AGENDA

HISTORIC LANDMARKS COMMISSION

May 17, 2016

HISTORIC LANDMARKS COMMISSION MEETING

Above: New doors, siding, fixed railing, improved driveway as of 5-6-16

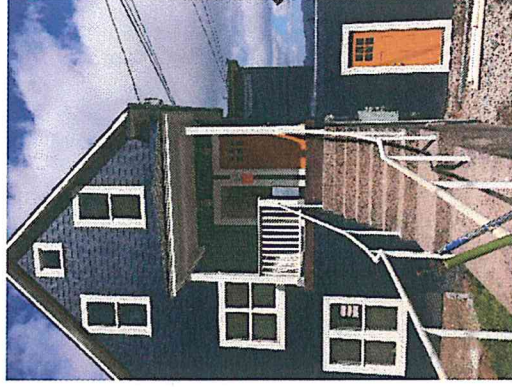
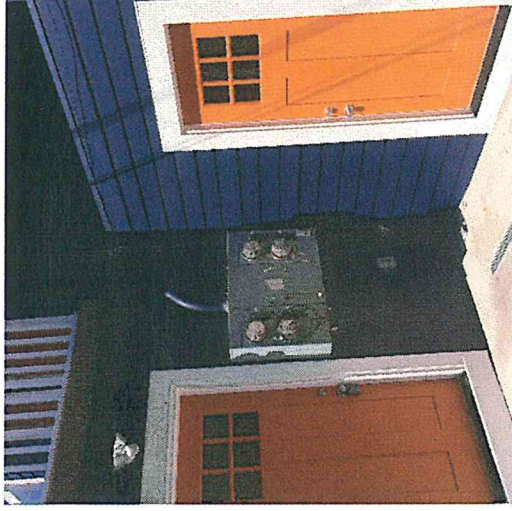
Vice President Dieffenbach confirmed that the garage door space would be in filled with new siding and a man door that were similar to the rest of the building. Ms. Lopez added that the building currently has three different types of siding, none of which are original. A few years from now, she hopes she can afford to reside the building with real wood. However, she is currently spending her money on the interior to make the building habitable. The house had some new windows and the four windows she has replaced are wood and fiberglass. The existing openings remained the same and Staff told her the windows needed to be Milgard Essence. The rest of the vinyl windows will remain until she can start making money on tenants. Then, window by window, she will get them all replaced back to the original wood style.

Commissioner Stanley said the project was presented to the HLC as if it had not been completed and the Applicant was seeking permission to complete the project. Ms. Lopez responded that she never said the work was not done. She had presented a big list of items that was narrowed down after working with the City. This presentation was delayed for two months and she was present now to answer questions.

1. Significant changes or modifications to the proposed plans as described in the previous Staff Report shall be reviewed by the Historic Landmarks Commission.
2. Any visible wood shall be free of pressure treatment incision marks, and all wood, shall be painted to match the house
3. The proposed door shall be installed to historic depth and dimensions and trimmed to match trim work on existing historic house.
4. All glass in the door shall be clear, and lites shall be true divided.

Proposed Shelter End View

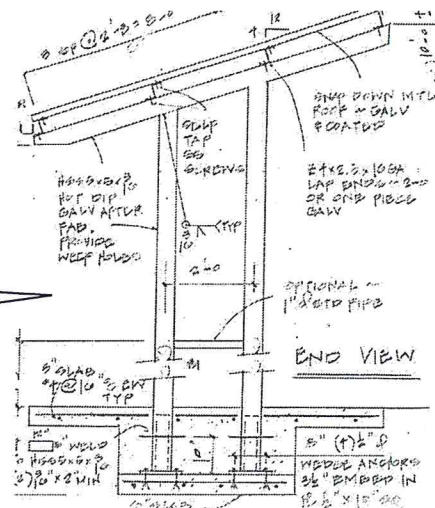
The two adjacent buildings to the east and west are two story approximately 30' tall. The John Jacob Astor Apartments located across the Duane Street right-of-way is an eight story building. The shelter is approximately 10' tall. The scale would be subordinate to and compatible with the existing buildings' height.

Significant changes or modifications to the proposed plans as described in this Staff Report shall be reviewed by the Historic Landmarks Commission.
